Subdivision Application

July 9, 2019

The subject property is about 52.80 acres in size and zoned RA (Residential Single Agriculture). The applicant is proposing to divide the subject property into 214 single family residential lots (within 11 Phases/Sections).

COBURN GRAND VIEW ESTATES

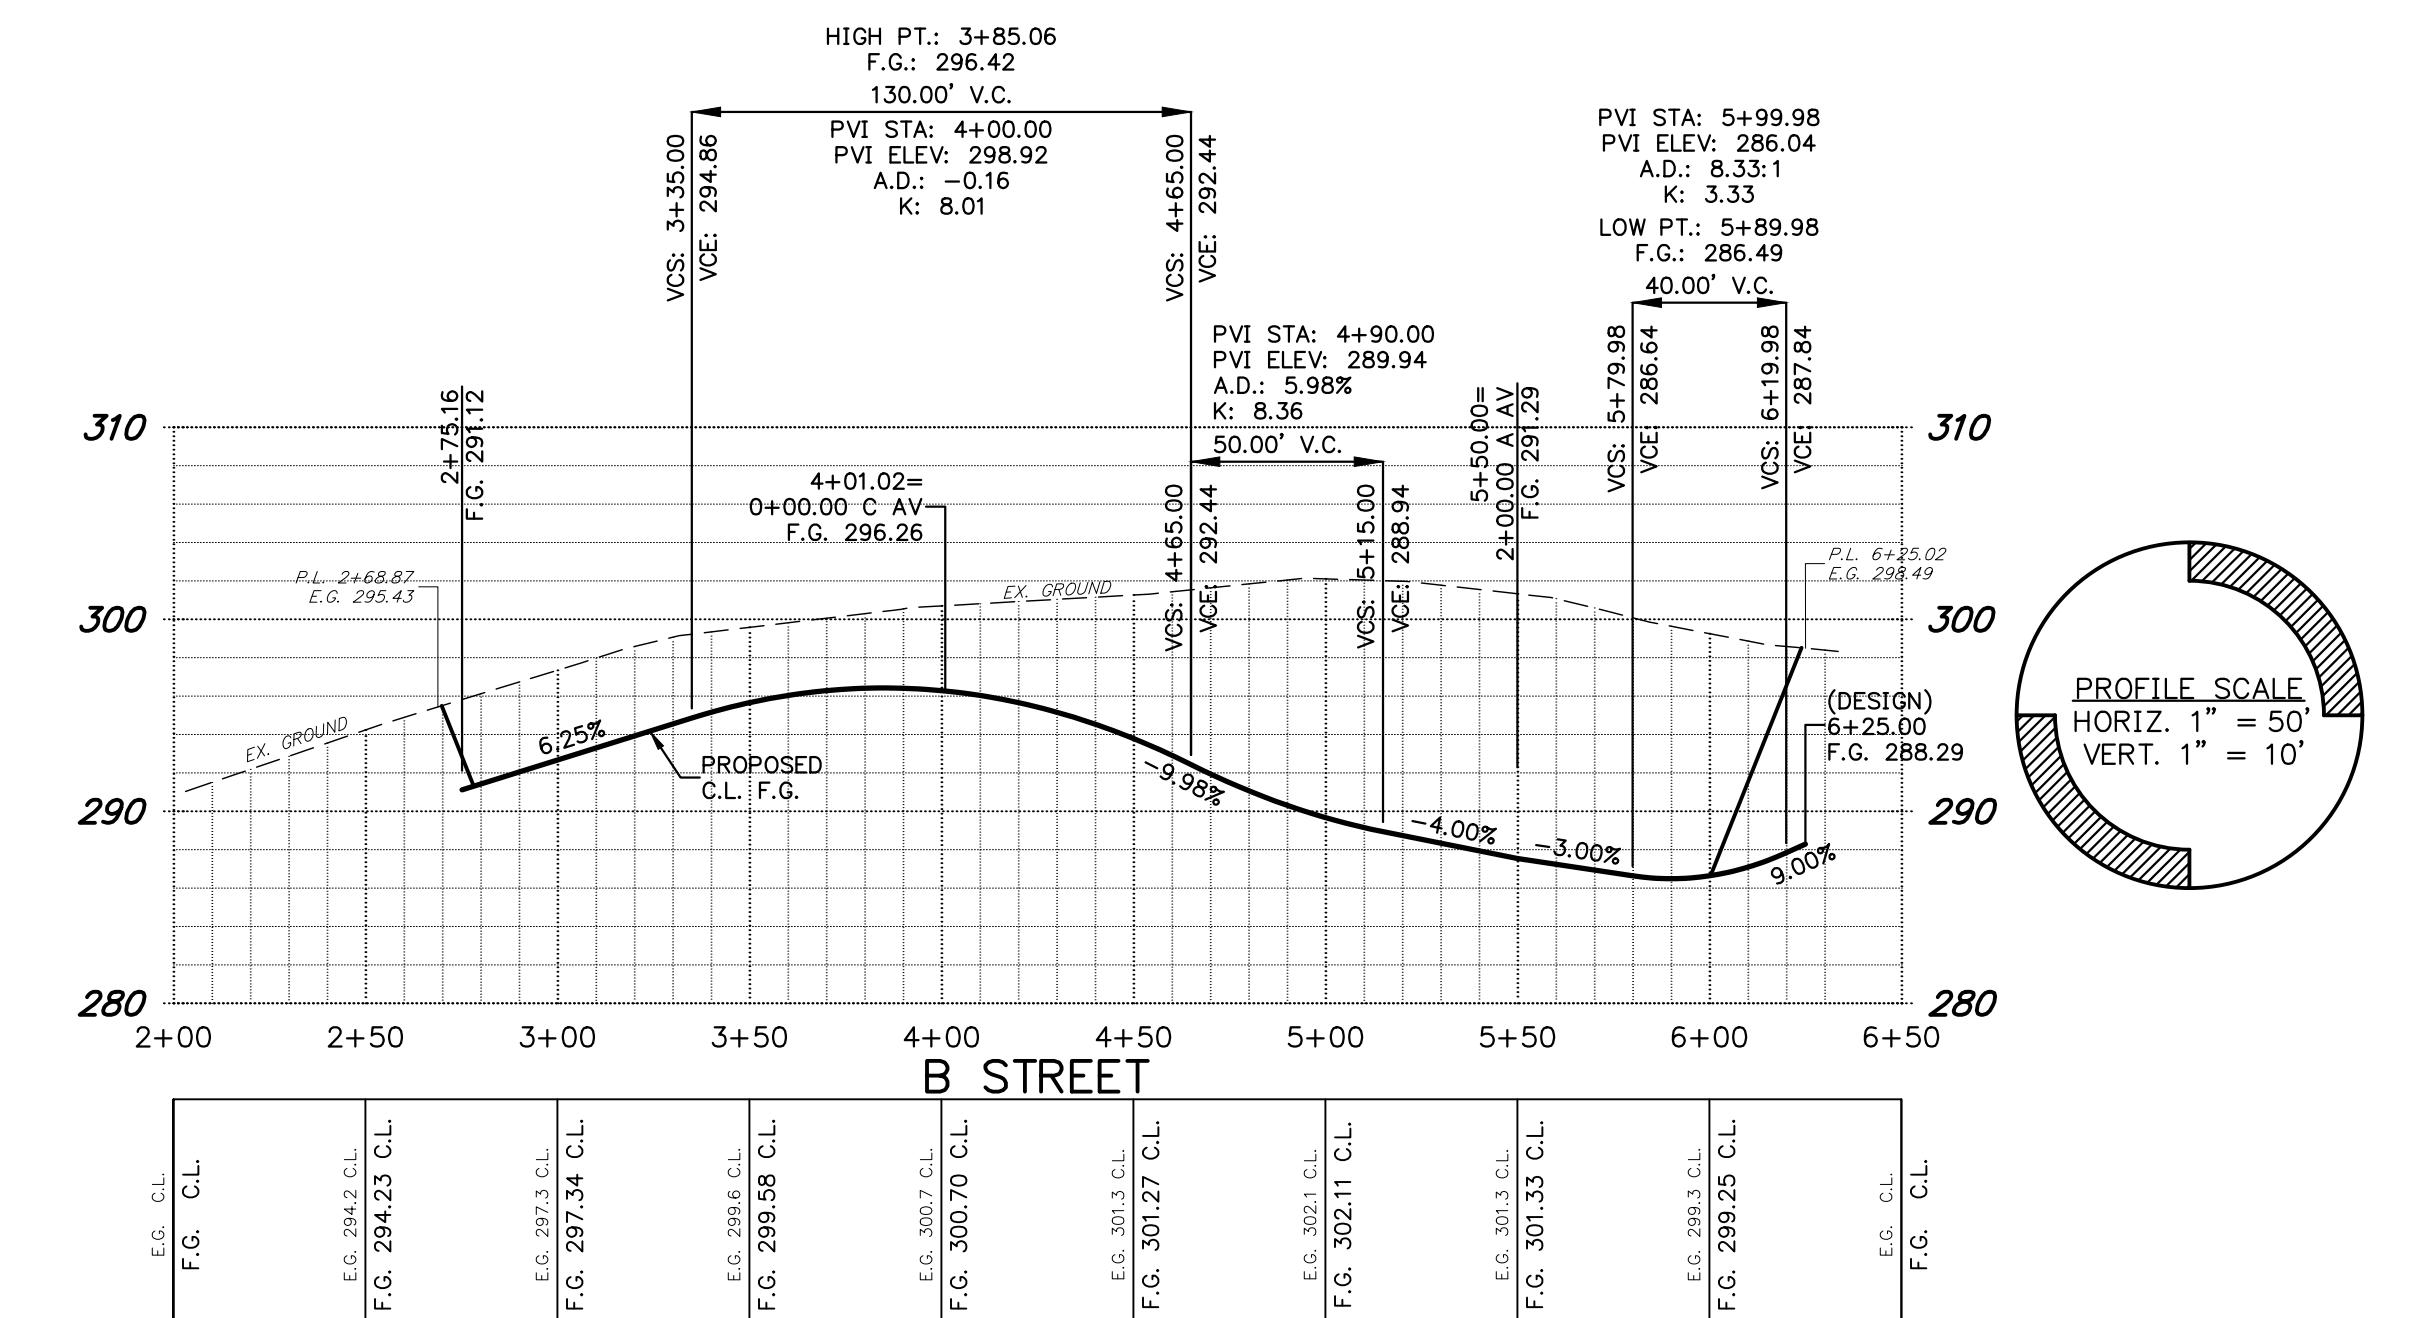
- (A)** The applicant is requesting an adjustment to street grades. As shown on Sheet 1 of 1, Slope Exception Areas Plan, sections of A Avenue, C Avenue, I Avenue, H Street, M Street, J Avenue, N Street, O Street, and P Avenue within the subdivision will have sections of the roadway with up to a 15% street grade. Due to the topography of the site and the proposed street alignment with existing streets, several streets will exceed the 12% street grade allowed. The areas proposed for slopes in excess of 12% are denoted on the plans and will not exceed a single run length of 200 feet.

- The natural grade within the subject property exceeds 12 percent in many areas. The applicant shall provide preliminary vertical street alignments to demonstrate compliance with the minimum standard of 12 percent street grade for local streets.*

- Plans have been revised and/or provided to show the street alignments and compliance with street grade.**
- Several lots will need to provide sprinklers, if the 12 percent street grade cannot be met. This includes K Street, and N Street. In addition, several Fire Department turnarounds need to be shown; the end of I Avenue, flag lot accessway, and Q Avenue.*

- The site plans have been revised and a design exception to street grade has been requested.**
- The proposed plan shows construction of a 50-foot wide right-of-way for M Street and a 40-foot wide right-of-way for K Street. The applicant shall modify the proposed plan to meet street standards, or submit findings indicating the necessity for the use of alternative street standards pursuant*
